## 4L60/65/70-E

### PRODUCTION CHANGES / INPUT SPEED SENSOR ADDED

## Technical Service Information

Figure 9

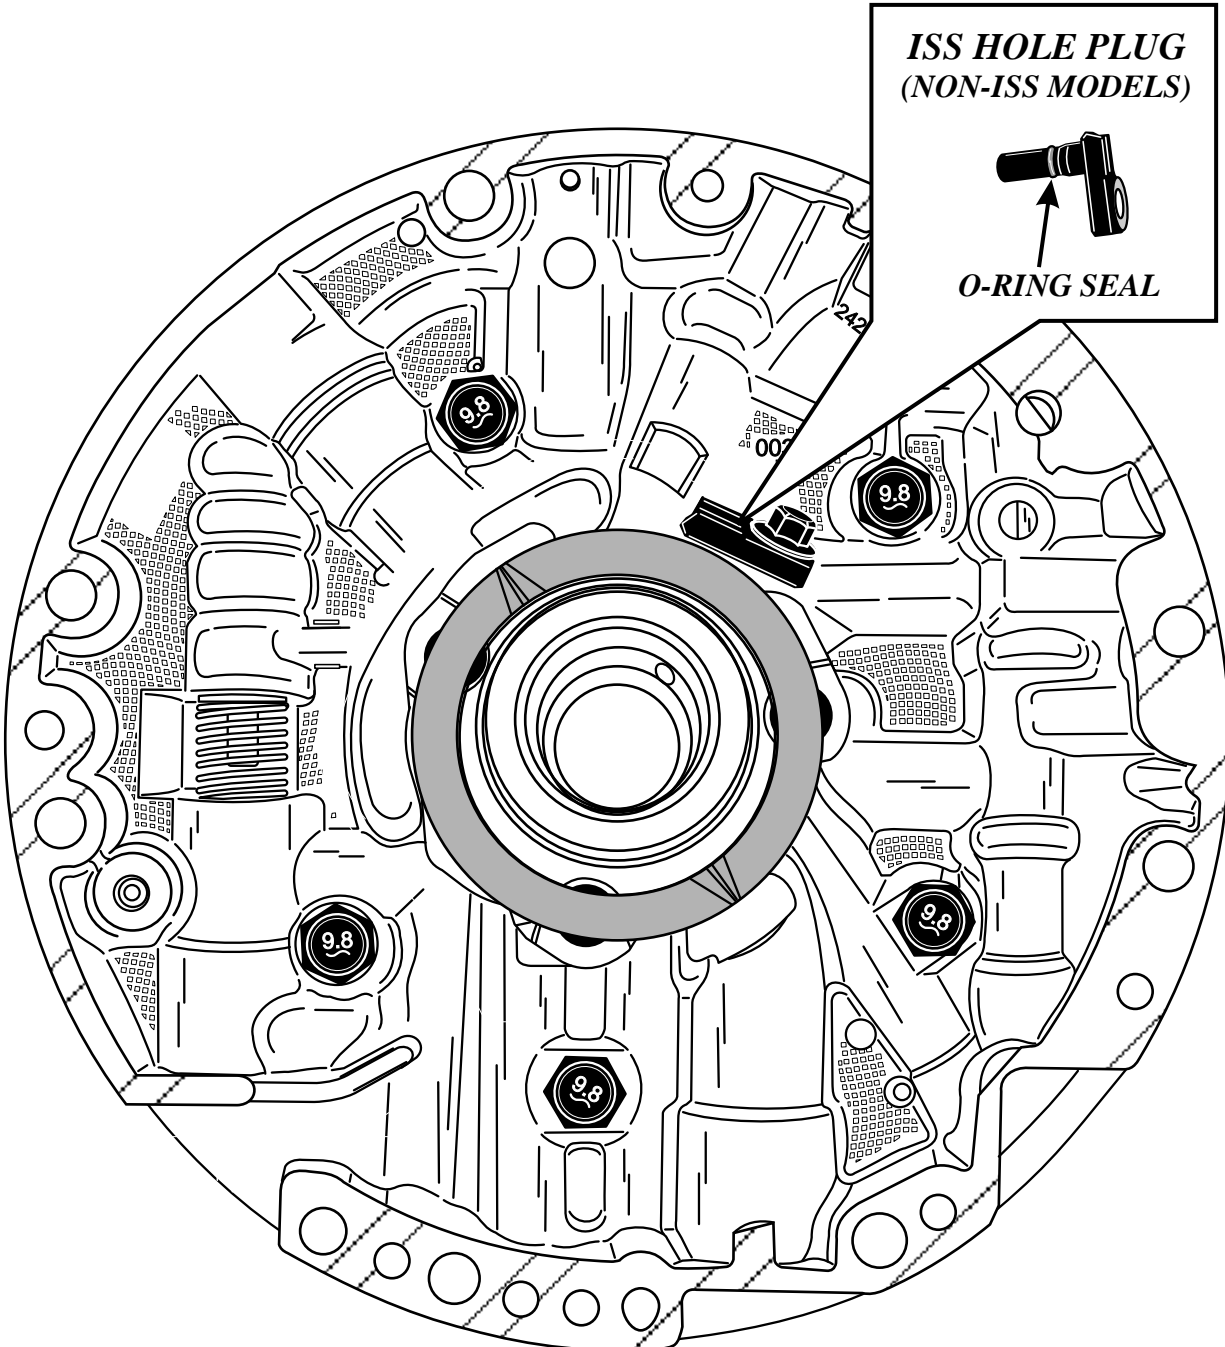
- CHANGE:** Oil pump cover changes also affected the stator shaft and stator shaft sleeve so as to relocate with oil passages within the oil pump cover.  
At the same time, the turbine shaft oil seal ring grooves were moved inboard towards the rear of the unit approximately 0.190”(in.) to create an area to manufacture 15 rotor teeth.
- REASON:** To correlate with changes in the stator shaft and sleeve assembly.
- CHANGE:** (4) Late in 2005 and early in the 2006 model year, some pre ISS models may still not have the ISS mounting holes machined into the cover. This will be evident as a smooth un-machined surface without the ISS mounting holes. As ISS models were introduced, the machining took place and the input speed sensor (ISS) was added. (See figure 8)  
For non ISS models, an ISS hole plug will be used in place of the ISS assembly.  
(See figure 9)

The boost sleeve and pressure regulator valve can not be serviced from the sump area on units equipped with an ISS because of the location of the ISS connector as shown in figure 8. This operation will require removal of the transmission and oil pump assembly. Pre ISS or non ISS models equipped with an ISS hole plug as seen in figure 9 will still allow access to the boost valve sleeve and pressure regulator valve from the sump. If the o-ring is damaged or omitted from the ISS hole plug then improper converter clutch operation or converter drain back concerns may be evident. Failure to install the ISS hole plug if required will result in low or no converter charge and no movement.
